PROPOSED TECHNICAL SPECIFICATIONS REVISIONS

BROWNS FERRY NUCLEAR PLANT

UNIT 2

(TVA BFN TS 272)

Figure 3.5.M-1  
BFN Power/Flow Stability Regions

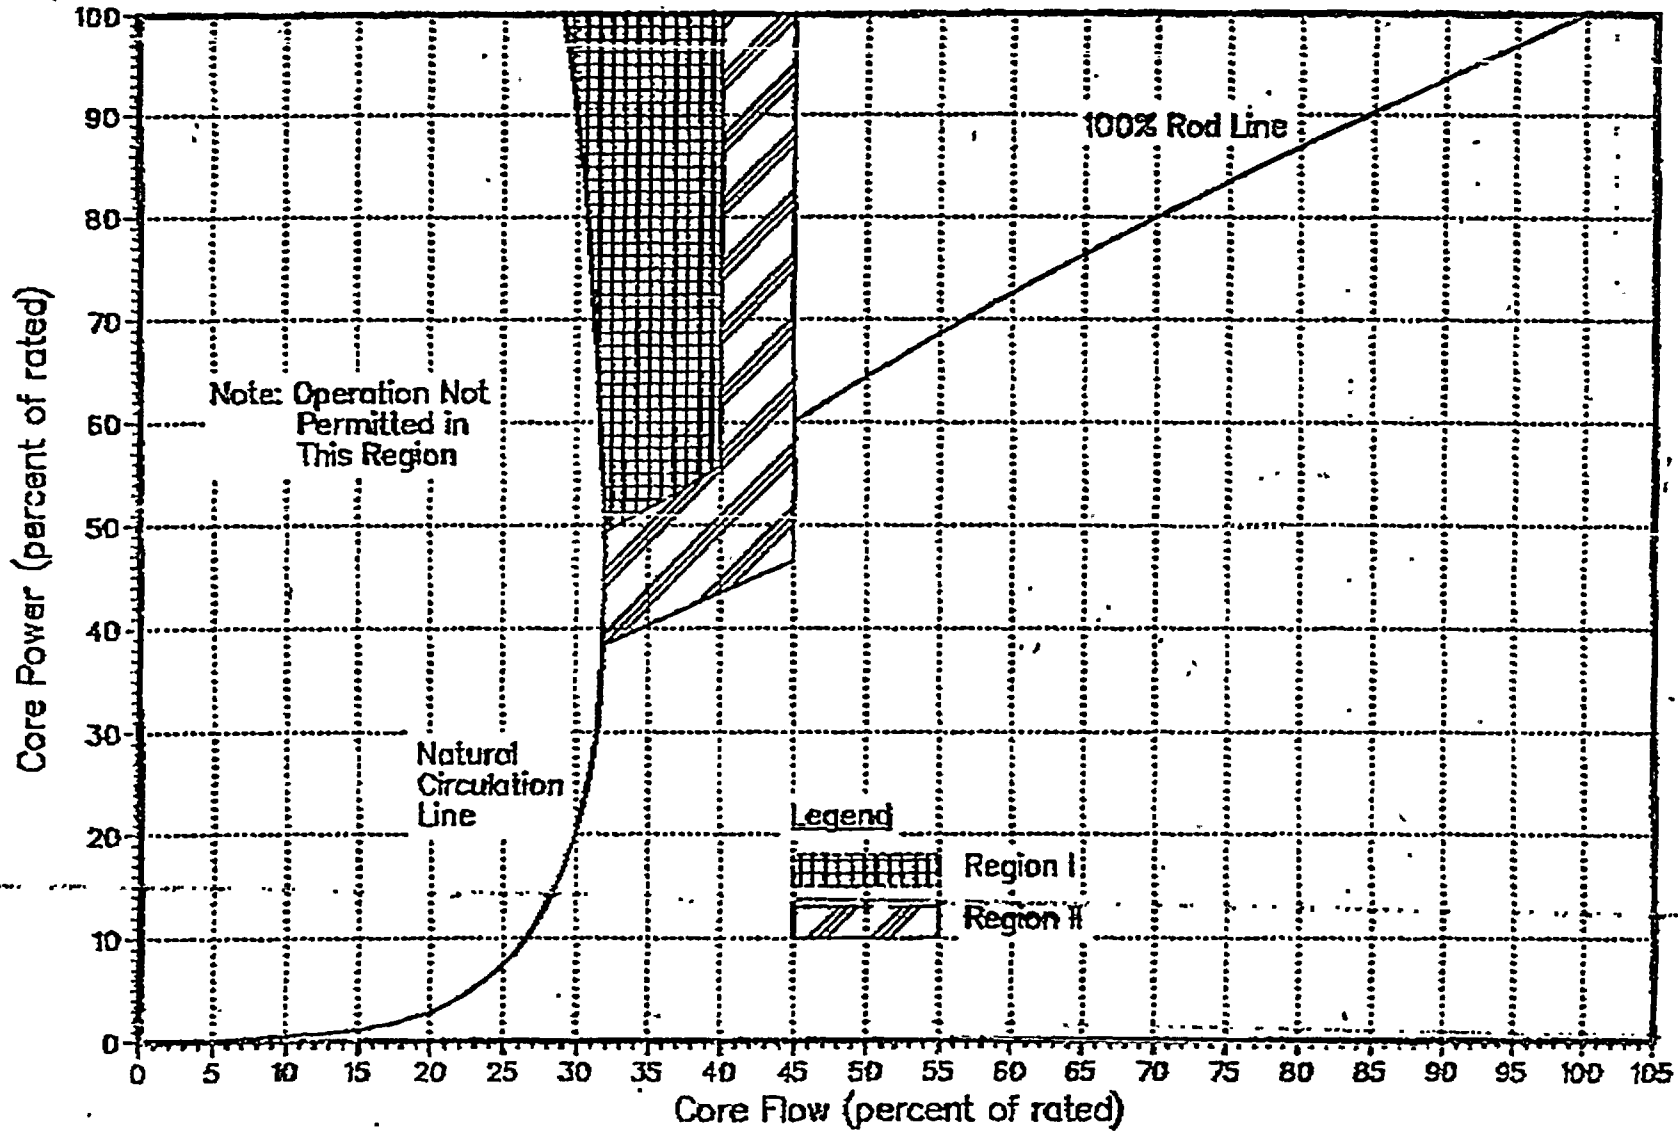
3. Add figure 3.5.M-1 (See attached)

Justification for Proposed Change Figure 3.5.M-1

Figure 3.5.M-1, "BFN Power/Flow Stability Regions," provides the operators a clear illustration as to what conditions of reactor core power versus core flow are acceptable or unacceptable. Based on this table and the appropriate LCO 3.5.M, an operator can identify what action needs to be implemented to exit an unacceptable region.
